Project:	<b>Highways England Spatial Planning Arrangement</b>	Job No: <b>60600479</b> <b>DM014.010</b>
Subject:	<b>South Caldecotte, Audit of forecast VISSIM model</b>	
Prepared by:	<b>Alex Pina Botella</b>	Date: <b>17/03/2020</b>
Checked by:	<b>Javier Pardo</b>	Date: <b>18/03/2020</b>
Verified by:	<b>Phil Arnold and Liz Judson</b>	Date: <b>19/03/2020</b>
Approved by:	<b>John Alderman</b>	Date: <b>20/03/2020</b>

This Technical Note (TN08) provides a summary of the audit work conducted on the revised Forecast Vissim model (dated 11<sup>th</sup> February 2020) developed for the A5 Kelly's Kitchen Roundabout by BWB. The Vissim model has been prepared to support the planning application of an employment development at South Caldecotte in Milton Keynes.

Figure 1. Vehicles overlap unrealistically at the southern stream of the roundabout.

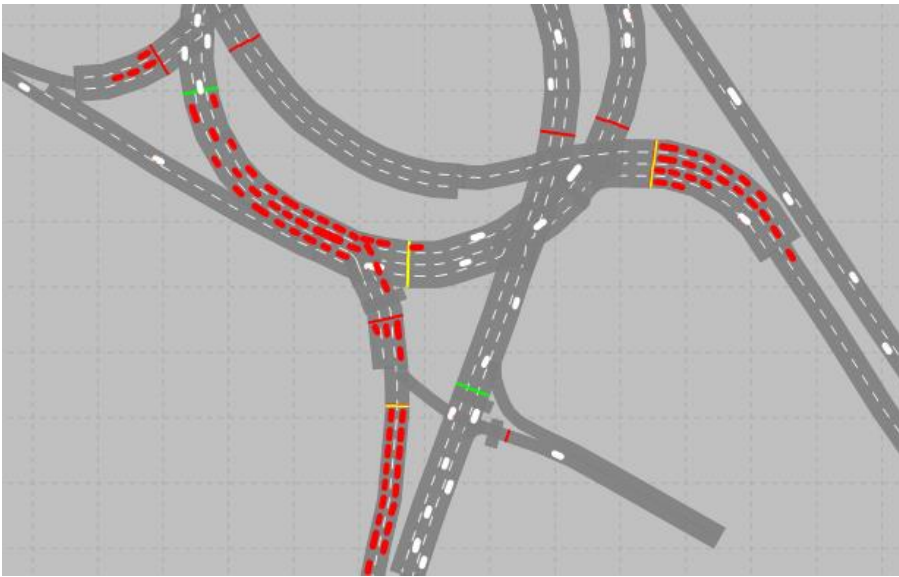
Whilst additional priority rules have been coded in the model to prevent overlapping vehicles on the southern stream of the roundabout, these have not been coded in all the necessary connectors, and overlapping vehicles still occur (shown in Figure 1). The frequency with which these occur is significantly lower compared to the previous model and will have a lower impact on modelling results. This issue is considered **MINOR**, however, it is recommended that appropriate priority rules are coded in all required connectors to avoid overlapping vehicles.

Figure 2. Excessive queuing inside the junction (Left – Do Something 2031, PM Right - Do Something 2031 AM)

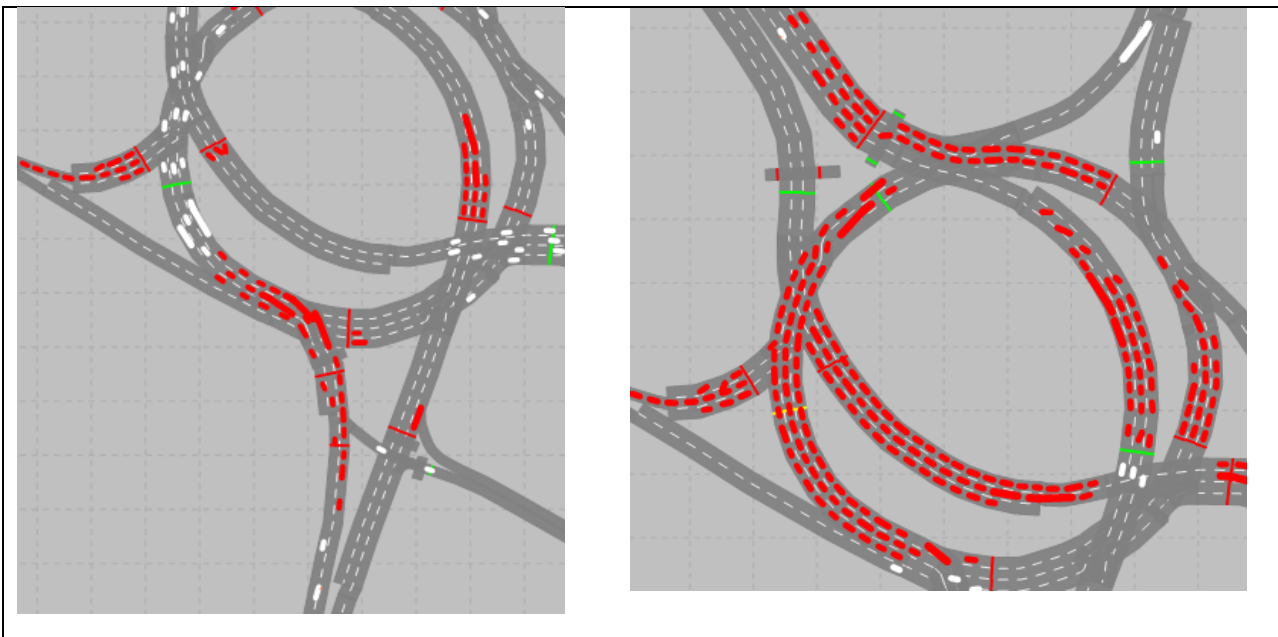
The changes made to signal controllers in this submission did not solve the issue regarding excessive queuing inside the roundabout. Figure 2 shows two snapshots of the model where excessively long queues form at the northern and southern circulatory links (refer to §2.1.3). This issue is considered **SIGNIFICANT** as this is not how the signal timings realistically would operate for safety reasons, with the additional risk the junction could lock up, hence the model does not reflect the likely operation and underestimates the queue lengths on arms approaching the roundabout.

It is recommended that this issue is addressed before a conclusive assessment of modelling results is made and conclusions about the suitability of the proposed mitigations are drawn. It is recommended that the average queues inside the roundabout should remain under approximately two thirds of the link lengths, to avoid safety issues.

**Figure 3. Stages and detectors on north and south stream 1 controllers.**

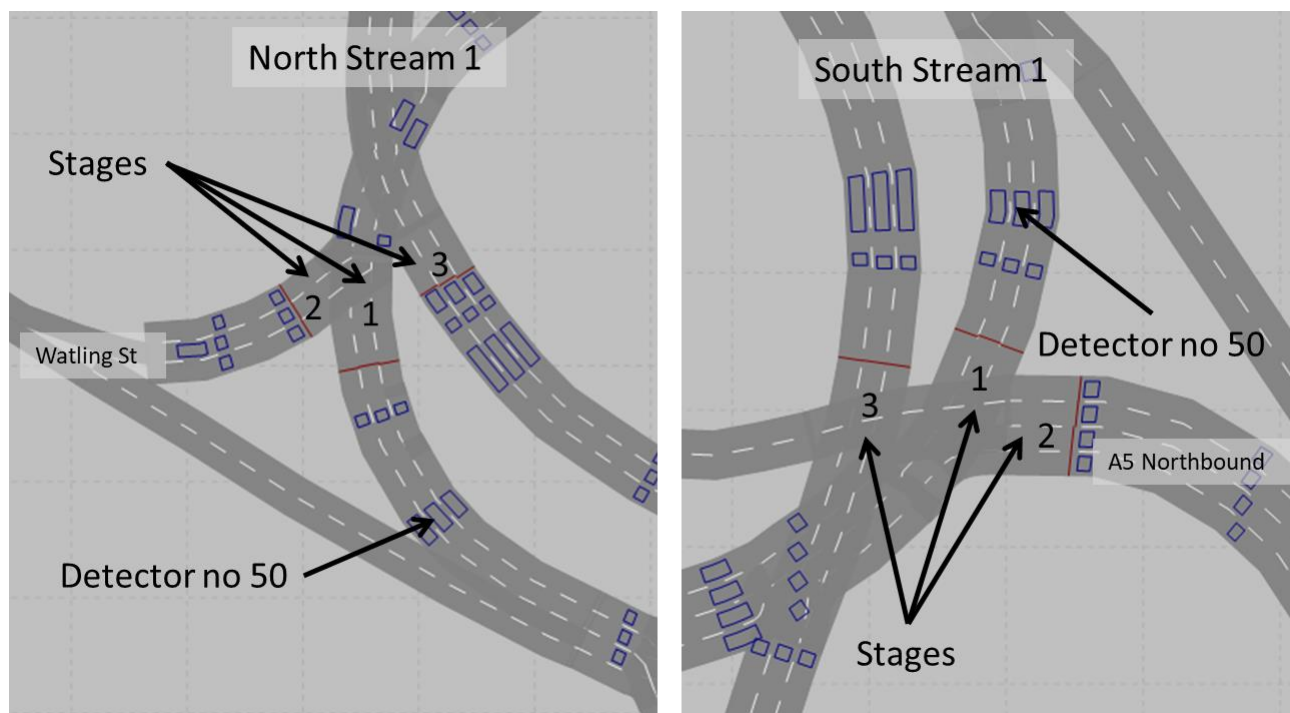
In more detail (refer to Figure 3), when Stage 2 is running, queues will build up inside the roundabout: once vehicles are at a standstill over detector 50 for a set period of time, the controller triggers a change from Stage 2 to Stage 1 or 3. The set time period over detector 50 has been increased from 3 seconds (in Reference Case and Do Minimum) to 6 seconds in the Do Something scenarios, increasing the length of the queue allowed within the roundabout. A 6 seconds gap between the queue reaching the limit of available queuing capacity and the beginning of the stage change is excessive and this contributes to the issue of excessive queuing inside the roundabout described in §2.1.2.

Changes in signal controllers are expected between scenarios to allow a better optimisation when the scenarios contain different flows. However, the changes relate to the amount of queuing allowed within the roundabout and there is no logical reason for this to increase in the Do Something scenario.

This issue is considered **SIGNIFICANT**. It is recommended that a consistent signal operation is used across all scenarios. Although signal timings can be optimised to different flow patterns, the model should reflect the same level of realistic queuing inside the roundabout in all scenarios.

**Figure 5. Modelled AM journey times.**

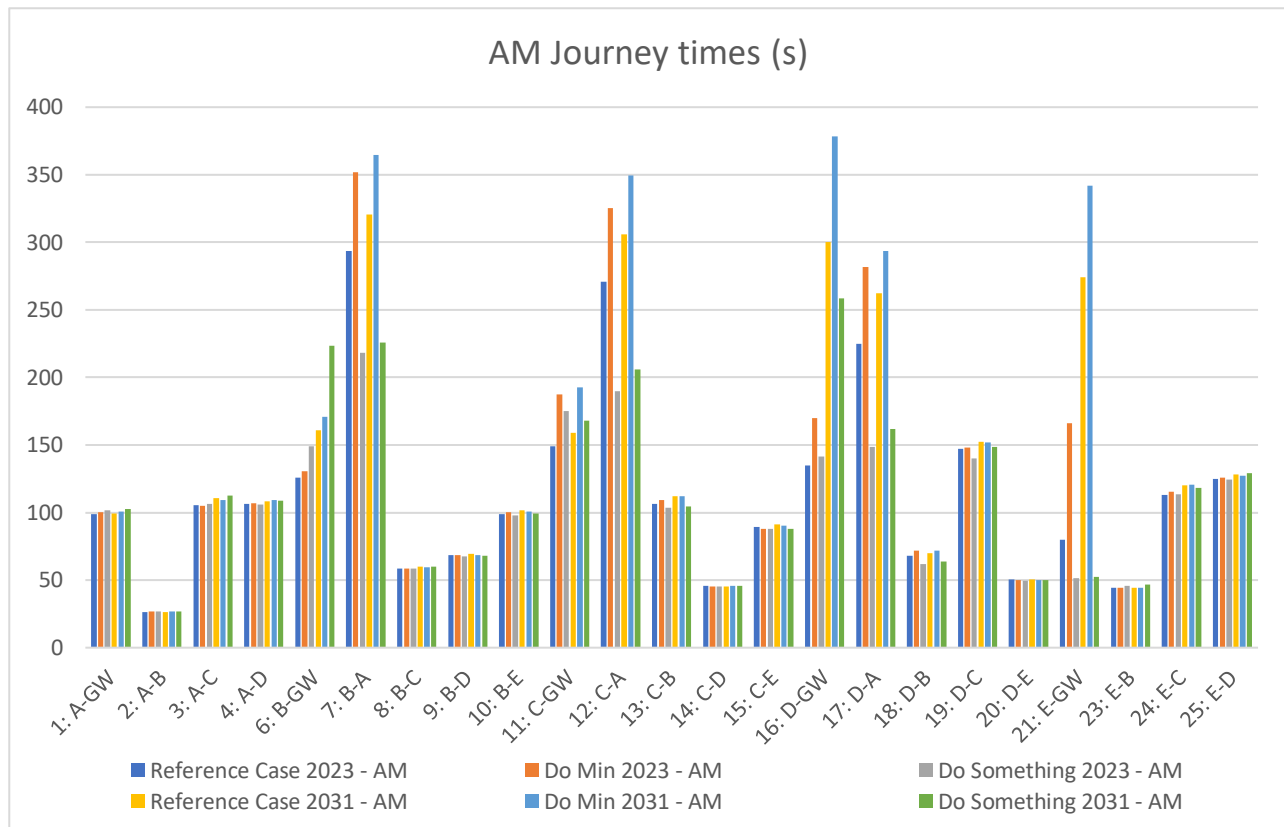
- The mitigations in the Do Something effectively offset the increase in journey times seen from the Reference Case to Do Minimum on all approaches to the junction except the A5 northbound (B-GW) and the A4146 (C-GW);
- The approach on the A5 northbound (B-GW) suffers a sharp increase in journey time in the Do Something scenarios;
- The mitigation at Tilbrook Roundabout results in a significant reduction in northbound journey times along Brickhill St (B-A, C-A and D-A); and
- The change in lane allocation at the southbound approach on the A5 (E-GW) in the Do Something scenarios result in a significant reduction of journey times, such that it is an improvement to those in the Reference Case.

Figure 6. Modelled PM journey times.

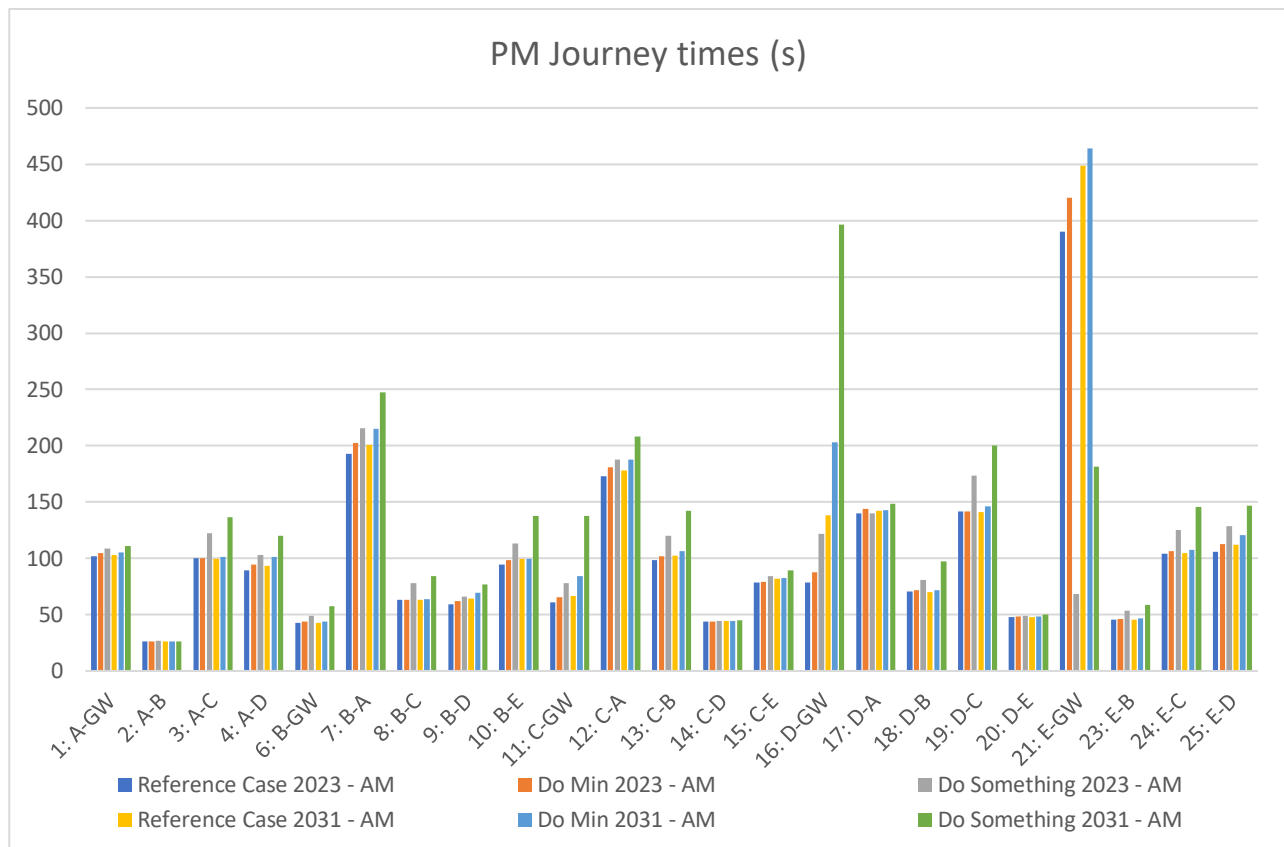
- The Do Something scenario journey times are slower than the Reference Case for all approaches and movements across the model except for the southbound approach on the A5 (E-GW);
- The approach on Watling St (D-GW) suffers an increase of over 250s in journey time from the Reference Case to the Do Something 2031 scenarios; and
- The southbound approach on the A5 (E-GW) in the Do Something scenarios is significantly faster than the Reference Case.

**Figure 7. Network Performance results for total delay<sup>1</sup> including latent delay.**

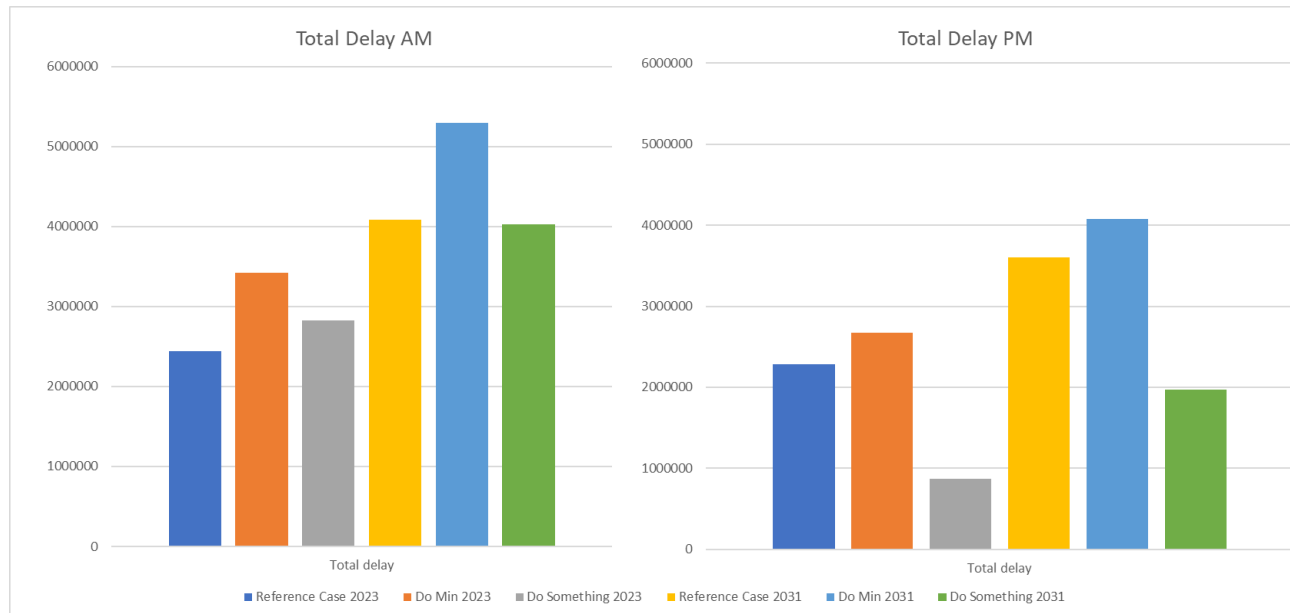
The total delay figures (calculated as the delay experienced by all vehicles loaded in the network, plus the delay experienced by vehicles that could not be loaded on to the network on time) indicates much of the delay caused by the development in AM is mitigated for, and there is less delay in the Do Something scenarios compared to the Reference Case scenarios in PM. It should be noted however that this assessment includes the mitigation at the Tilbrook Roundabout. Taken in isolation based upon the Journey Time results the A5 Northbound approach is worse off with the proposed development. In addition it is unclear how representative this is of a true comparison, results could vary significantly if the internal queue detectors/signal operation were consistent across all scenarios. It should also be noted that there is considerable variation in journey

times suggesting the A5/A4146 will be overloaded with significant delays on some approaches. The latent demand indicates, that due to congestion, not all vehicles are able to enter the model network.
